Informal document GRSG-107-22,  
(107th GRSG, 30. Sept.-3 Oct., 2014  
agenda item 5)

# **Panoramic Sunroof Issue**

**OICA/CLEPA-comment on the national defect investigation and the proposed amendments to toughened glazing by the Republic of Korea**

OICA, CLEPA  
2014-09-25

# 227 g Ball Point of Impact

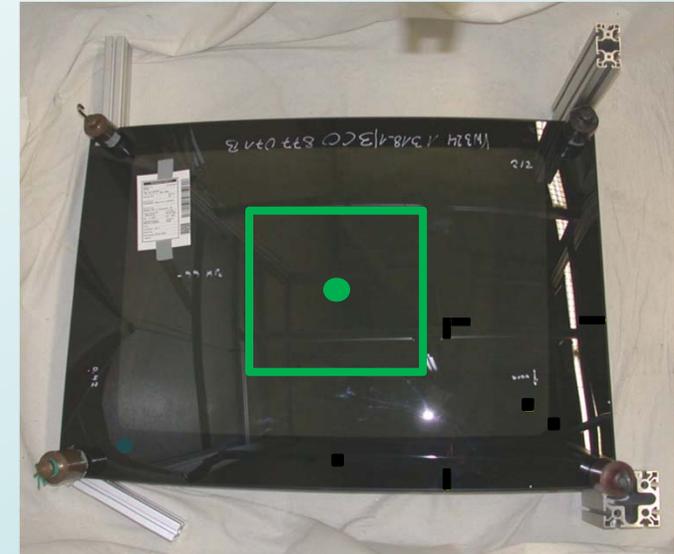
**ISO 3537:** „The point of impact shall be within 25 mm of the **geometric center of the test piece**”

**UNECE:** Geometric center of the test piece or Geometric center of the finished product

**FMVSS:** (Geometric) Center of the Test Piece

**GTR 6:** As UNECE  
Center of supported area (error on Page 34  
→ wording needs to be corrected)

**KOR Proposal :** Center of the supported Area (**GRSG 106-10, GRSG 107-06**)

- According to international standards, the point of impact is the geometric center of the test piece
- The Korean proposal includes the typing error from GTR 6

1. The wording error on #6 of GTR 6 should be amended:
  - Replace “centre of the supported area” by “geometric centre of the test piece”.
  - Justification: Corrigendum of GTR 6 with respect to the technical rationale of GTR6 (impact test procedure same as ISO 3537/UNECE).
2. Industry is ready to discuss on any clarification in UNECE regarding the application of ceramic coating for toughened sunroof glazing, if needed.
